HISTORIC AND DESIGN REVIEW COMMISSION

June 29, 2022

HDRC CASE NO: 2022-342
ADDRESS: 421, 423, 431 S ALAMO ST
LEGAL DESCRIPTION: NCB 155 (SAUTO HOTEL II), LOT 36
ZONING: D, H, RIO-3
CITY COUNCIL DIST.: 1
DISTRICT: La Villita Historic District
APPLICANT: James McKnight/Brown & Ortiz, PC
OWNER: Eric Stone/SAUTO HOTEL II LC
TYPE OF WORK: Rehabilitation and exterior modifications of the historic German School structures, construction of a 10-story hotel, site work, site construction
APPLICATION RECEIVED: June 13, 2022
60-DAY REVIEW: Not applicable due to City Council Emergency Orders
CASE MANAGER: Edward Hall

SHEET NO.
L3.00

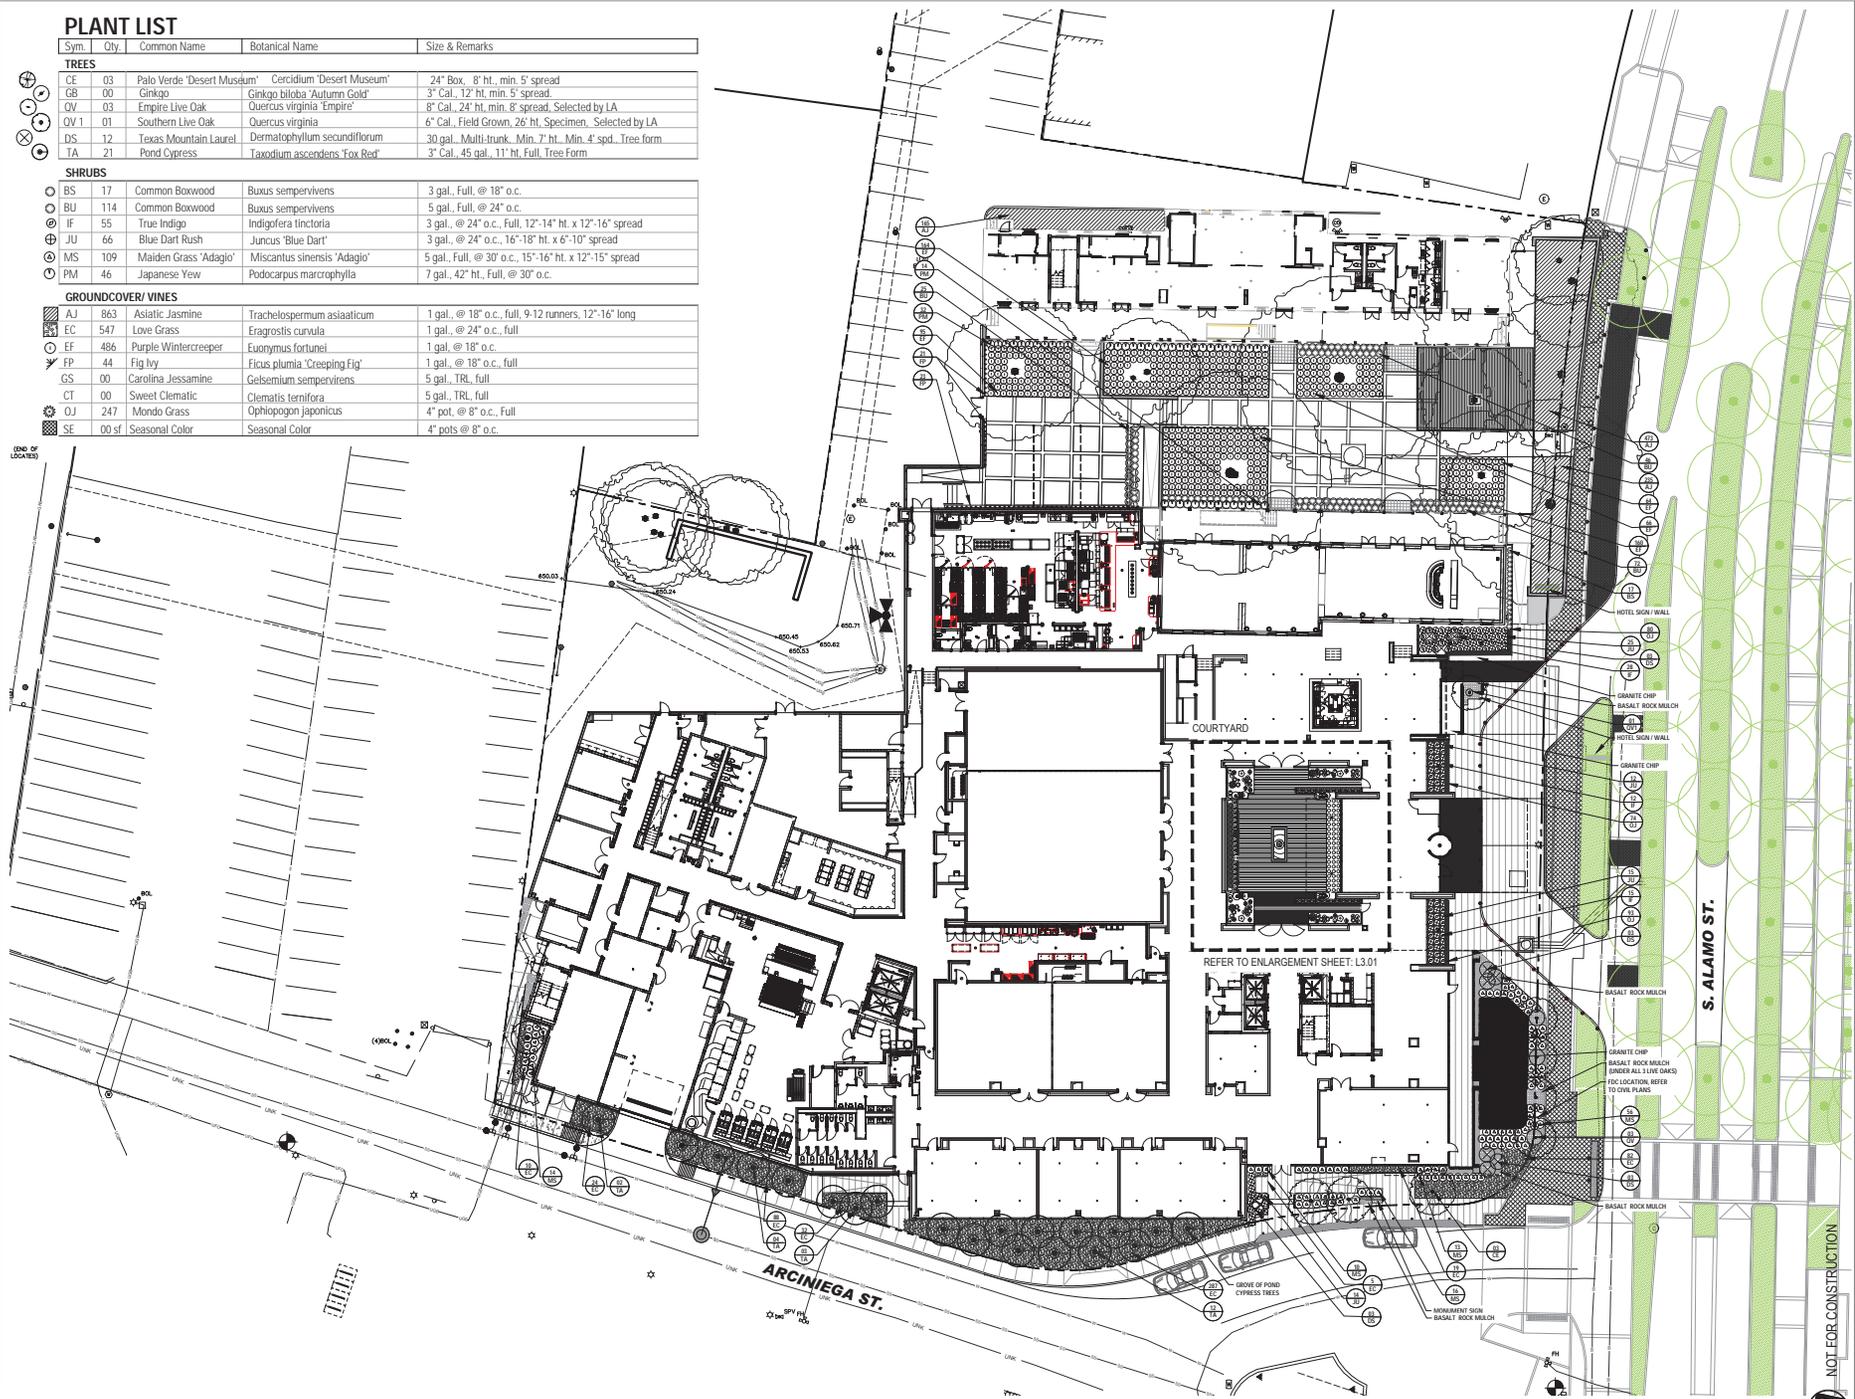
- 3a. The applicant is requesting a Certificate of Appropriateness for approval to perform modifications to the existing courtyard to include the installation of new trees, shrubs and groundcover. The applicant has also proposed to construct a retractable awning within the courtyard. Generally, staff finds the proposed modifications, as noted on the most recent site plan to be appropriate; however, staff finds that the applicant should submit a detailed site and landscaping plan for review and approval. Additionally, staff finds that a detail of the proposed courtyard awning should be submitted for review and approval. The proposed awnings should feature materials, details and profiles that are complementary of the historic structures.

Please see Sheet L3.00 Planting Plan Level 1 for an illustrative landscape plan

Please refer to sheet L3.00. In the new Alamo Street Improvements the sidewalk is set back from the curb line, and dropped to street elevation. Our sidewalk is proposed to be continuous, and protected with bollards at vehicular access points

SHEET TITLE
SOUTH GERMAN BUILDING - EXISTING, DEMOLITION & NEW FLOOR PLAN

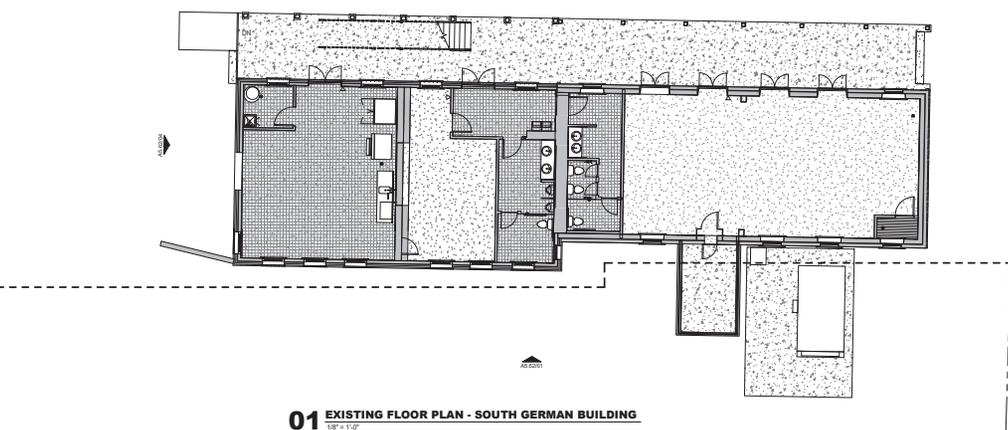
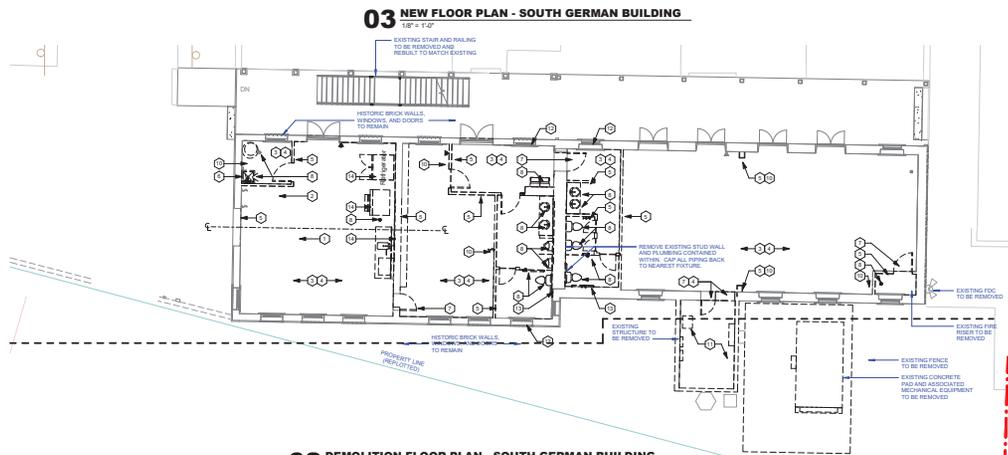
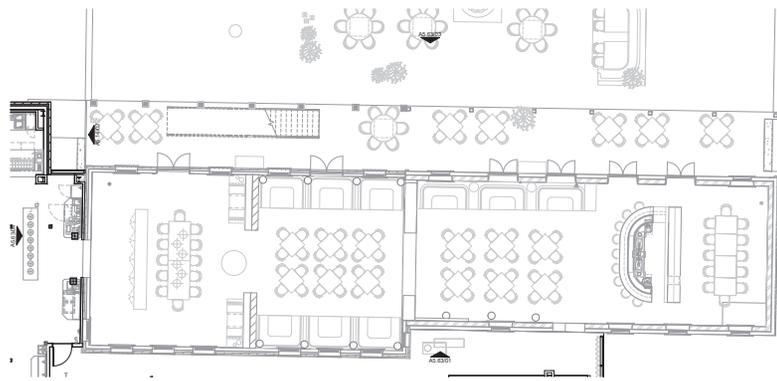
- 2a. The applicant is requesting a Certificate of Appropriateness for approval to perform scopes of work to the German School's South Building to include window repair and the replacement of an existing staircase. The applicant has also proposed to replace existing, exterior doors, and to create two (2) new door openings within the existing facades. Generally, staff finds the proposed window repair and staircase replacement to be appropriate; however, all work shall be done in-kind with like materials. Staff finds that only non-original doors should be replaced. If original doors are damaged beyond repair, they should be replaced in-kind.
